PATHFINDER

December 26, 2002

Ref: Docket No. 40-6622, Source Material License No. SUA-442

Pathfinder requests an amendment to the above referenced license to modify or delete various license conditions that have become obsolete in light of the current status of the Shirley Basin mill/tailings site. Each condition that we wish to address is itemized below with discussion.

**Figure 5-1
Organizational Chart**

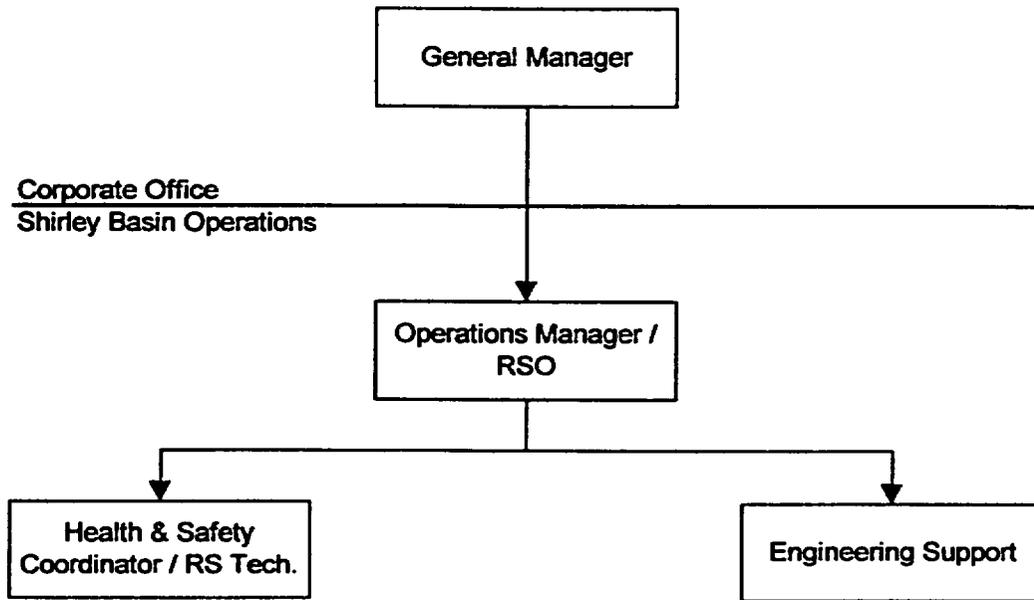
11) **Condition 52.** Modify to reference the organization chart enclosed with this submittal.

Discussion: The organization structure has undergone some changes since the last submittal (Attachment 2).
